### GUELPH CITY COUNCIL

**January 14, 2008 - 7:00 p.m.**

Special Meeting of City Council to hear delegations on the Hanlon Expressway Environmental Assessment with respect to the proposed improvements.

**SUBJECT:** Highway 6 (Hanlon Expressway) EA Project GWP 3002-05-00  
(Ward 5 and 6 with City Wide Implications)

Fig. 3

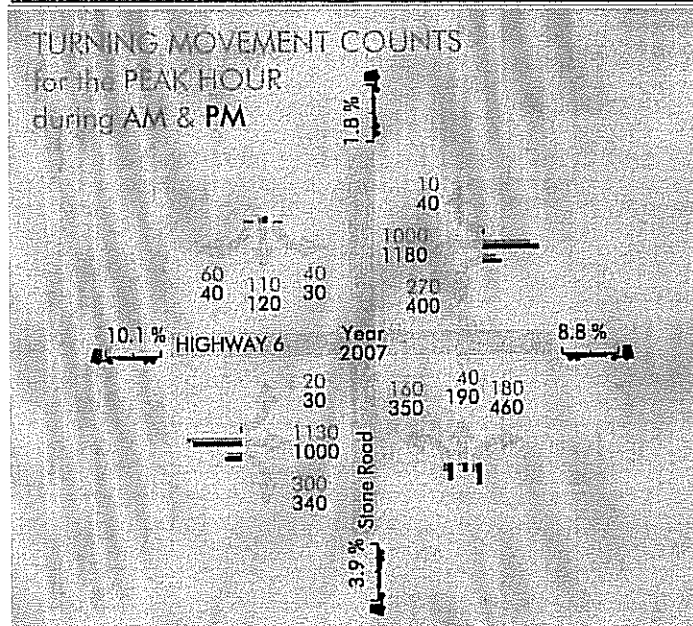
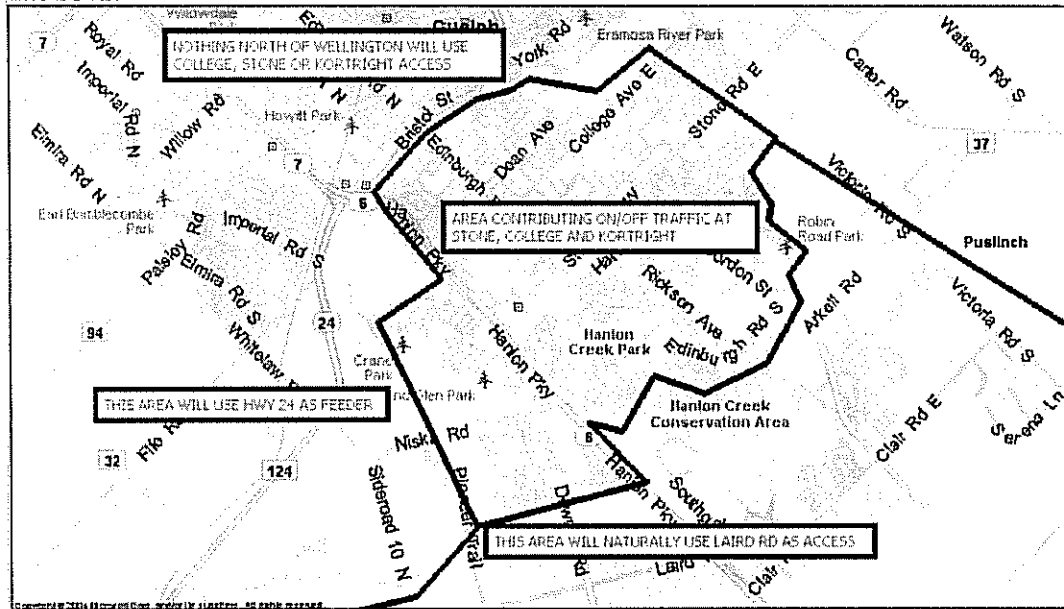
The MTO appears to have considered various interchange configuration and decided that the PARCLO A is the most efficient. This may be the case when the interchanges in question are more equally traffic loaded. In the case of Stone/Hanlon, there is a very great difference between Stone and Hanlon volumes. It is also unlikely that there will be any significant growth in Stone East/West traffic in future (Fig. 3).

LOGICAL ACCESS AREA FOR COLLEGE, STONE AND KORTRIGHT INTERSECTIONS  
NOTE THAT GROWTH AND ACCESS TRAFFIC HAS PLATEAUED, WITH NO SIGNIFICANT GROWTH POSSIBLE. ONLY HANLON THROUGH NORTH/SOUTH TRAFFIC GROWTH EXPECTED

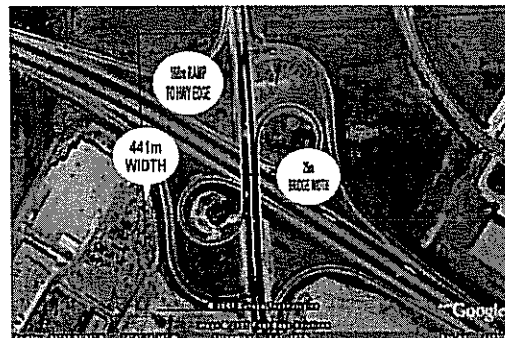
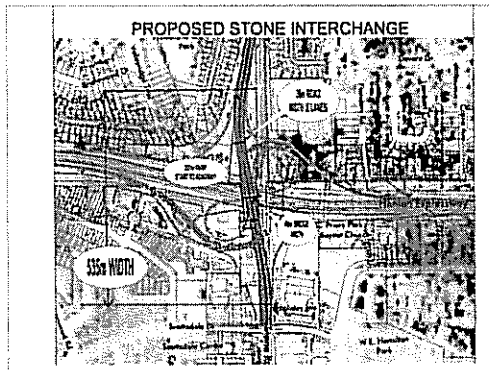
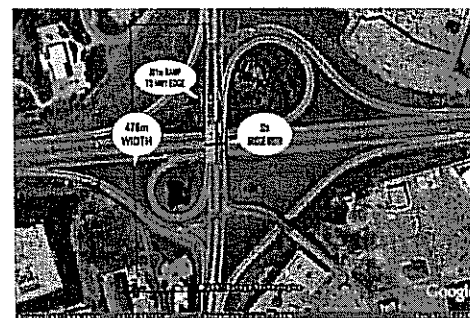
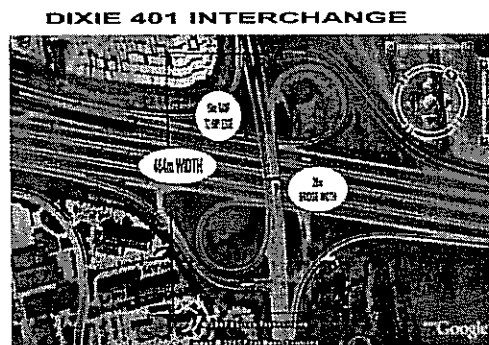
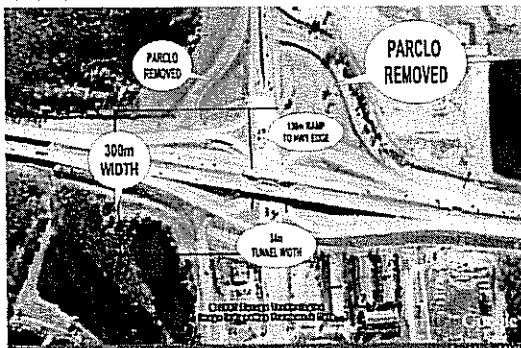
The proposed PARCLO Stone interchange is completely out of scale with the available space or requirements.

INTERCHANGE SIZE COMPARISONS				metres
INTERCHANGE	ARTERIAL WIDTH	RAMP TO ROAD EDGE	ROAD WIDTH	BRIDGE WIDTH
STONE PIC 2 PARCLO A	535	227	26	40
WINSTON CHURCHILL/401	441	168	21	25
DIXIE/401	464	154	24	28
Hwy 24/401	476	201	24	32
I65 SPUI	300	130	28	34
PIC 1 DIAMOND	200	75	20	26

20% WIDER THAN WINSTON  
15% WIDER THAN DIXIE RD  
12% WIDER THAN 24/401  
78% WIDER THAN I65/IN46  
167% WIDER THAN DIAMOND  
SHOWN IN PIC 1.

MTO 400 Series guidelines call for Acceleration/Deceleration ramps to be at least 150m long. The proposed Stone PARCLO has ramps in excess of 400m.

Why such overscale at this interchange?

**PARCLO A AS PRESENTED AT PIC 1**

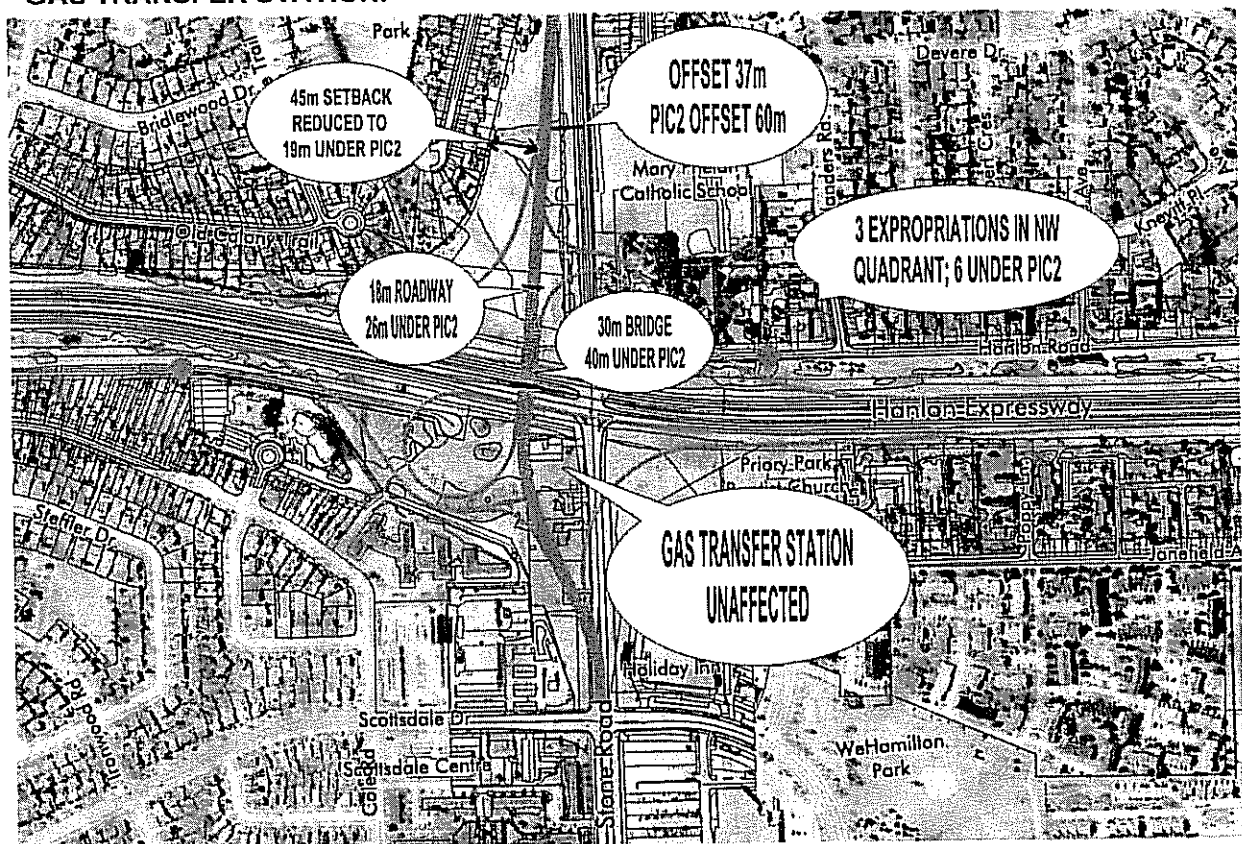
**The PARCLO A in the PIC#2 Preferred design is NOT THE PARCLO A OPTION PRESENTED IN THE PIC#1 DOCUMENTS.**

PARCLO A PIC #1 was a 4 lane Arterial with an 18m wide roadbed offset 37m South from the current roadway, and a 30m wide bridge over the Hanlon. This design avoided the Gas Transfer station and was set back 45m from the Wagoners Trail property lines.

PARCLO A PIC #2 is a 6 lane Arterial with a 26m wide roadbed offset 60m South from the current roadway, and a 40m wide bridge over the Hanlon. This design requires relocation of the Gas Transfer station, and encroaches to within 19m from Wagoners Trail properties.

**THE PARCLO A INTERCHANGE PRESENTED AT PIC1 IS DRAMATICALLY DIFFERENT FROM THE DESIGN PRESENTED AT PIC2. THE ROADBED IS WIDENED TO 3 LANES AND OFFSET AN ADDITIONAL 23m SOUTH, IMPACTING WAGONERS TRAIL AND THE GAS TRANSFER STATION.**

**HOW CAN MTO CHANGE THE DESIGN IN THE MIDDLE OF THE PUBLIC CONSULTATION PROCESS? IS THIS SIMPLY A METHOD TO BACK-DOOR THE MTO PREFERRED OVERSIZED DESIGN?**

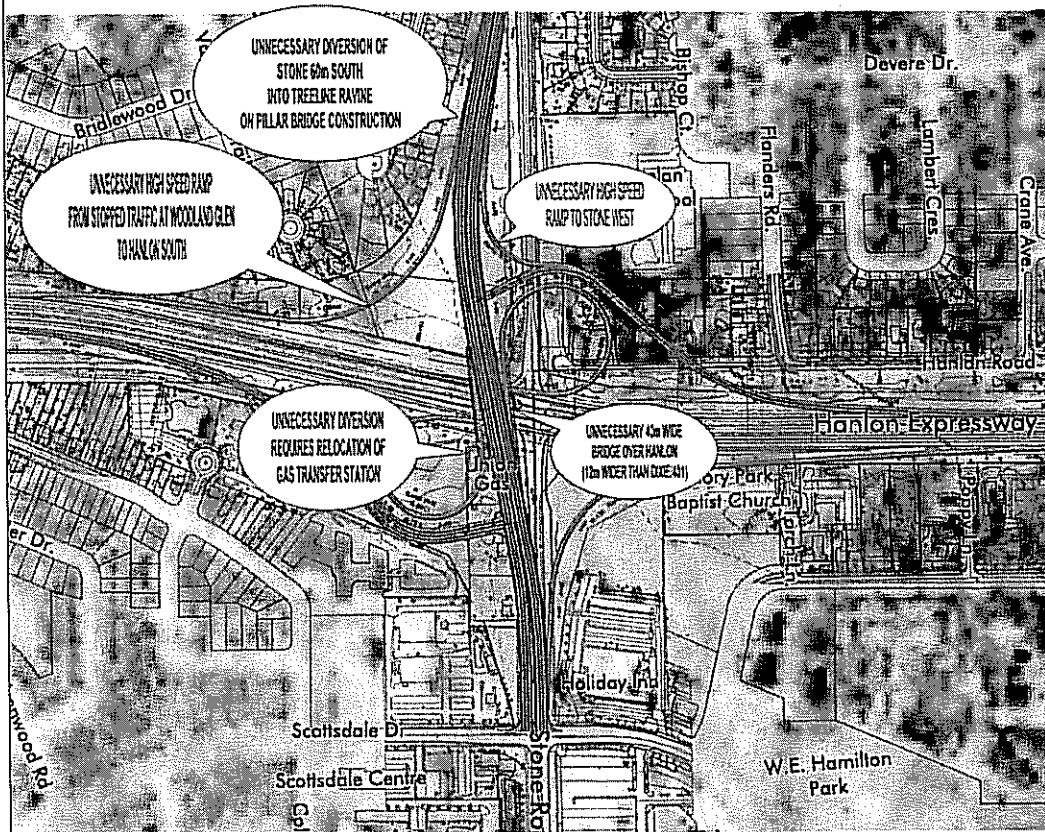
The proposed PARCLO A at Stone Road is a series of errors and misconceptions, compounding one upon the other.

The original design, and current alignment, both horizontal and vertical, are consistent with an on-ground roadway and bridge with a Diamond interchange.

Stone is fully built up, and posted at 60km/h. There is an intersection at Woodland Glen and again at College Ave. There is no future potential for high-speed traffic on Stone.

**Why does the MTO Preferred PARCLO have a high-speed ramp from Hanlon South to Stone West?**

Exhibit 5-8 Recommended Speed on Horizontal Curves to Avoid Skidding (Low Speed)

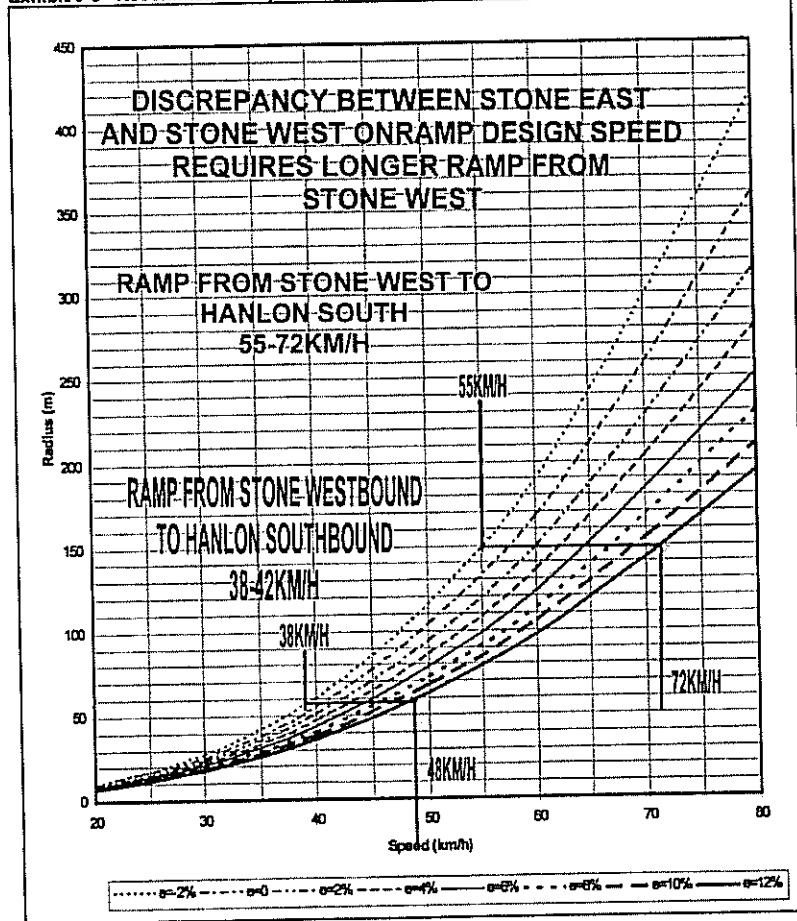
The unnecessary high speed Stone West ramp forces the main roadway 60m south of the existing roadbed, and into a Multi Million dollar construction of pillar and concrete spans.

The unnecessary radius increase of the Stone to Hanlon South ramp forces the entire roadway to within 19m of the Wagoners Trail properties.

If Stone East to Hanlon South is a 42km/h ramp, why does Stone West to Hanlon have to be a 72km/h design into Wagoners Trail?

The Southward diversion forces the roadway through the Union Gas Transfer Station, taking out a few more Million dollars of our tax money.

### THE MYTHICAL MAGICAL PEDESTRIAN AND BIKE LANE ACROSS A PARCLO A4 INTERCHANGE. TOTALLY IMPOSSIBLE AS THE DETAILED DRAWING SHOWS

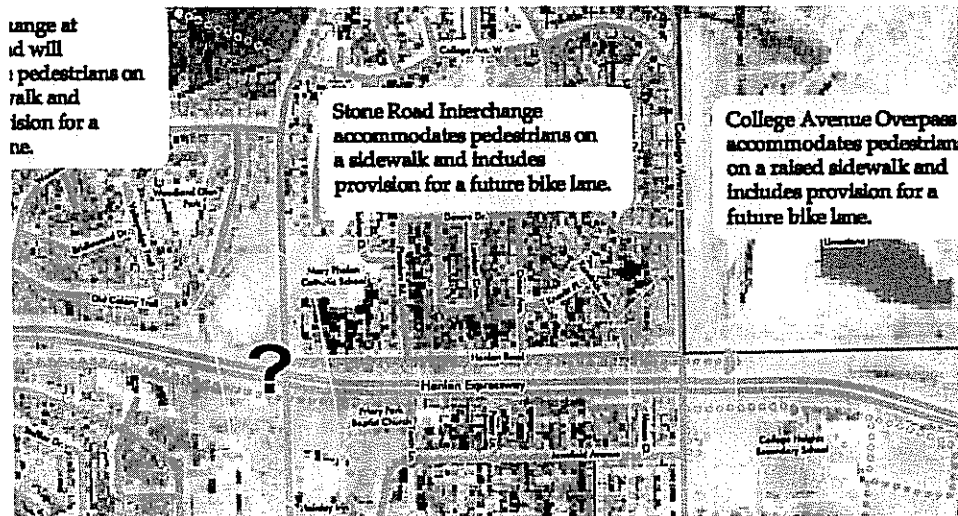
Residents of the Woodland Glen and College subdivisions regularly walk or cycle to Stone East. The information presented at PIC#2 shows a nebulous pedestrian and cycle crossing of the preferred PARCLO A Interchange. As a pedestrian crossing of a

PARCLO uncontrolled on or off ramp takes 3 times as long as an intersection crossing, there is no safe pedestrian or cycle crossing of a PARCLO A. This is probably why the MTO has shown it in such detail.

### PED OR CYCLE CROSSING OF A PARCLO A (ALMOST IDENTICAL 401/MAVIS USED AS EXAMPLE)

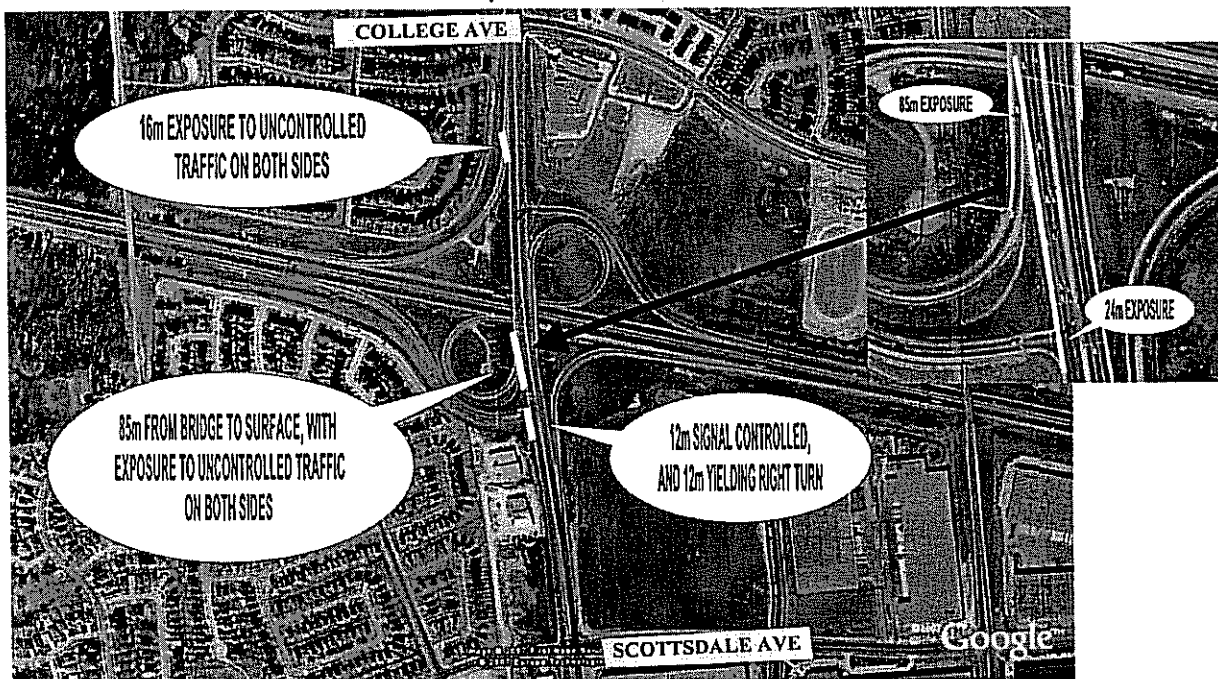
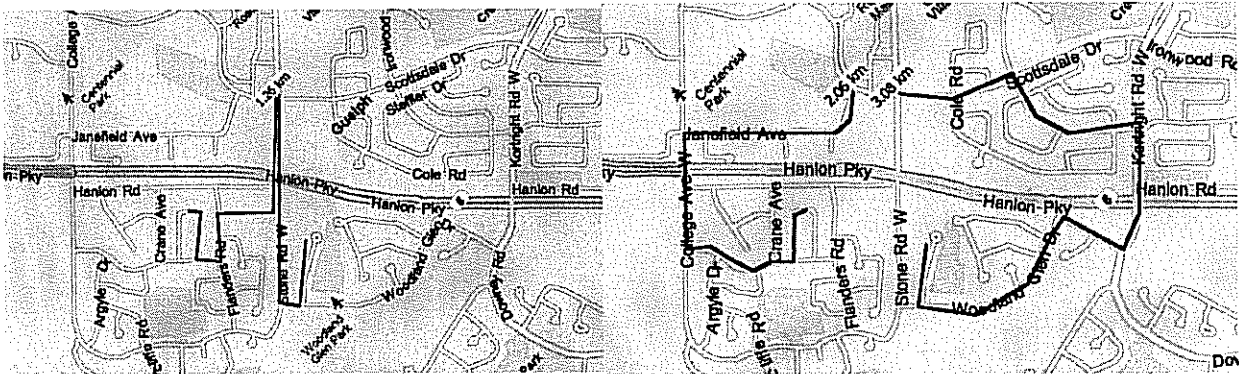
Any pedestrian or cycle crossing of a PARCLO requires long exposure to uncontrolled on both sides. (Imagine walking or cycling this line when some idiot on a cell phone decides he has missed his ramp)
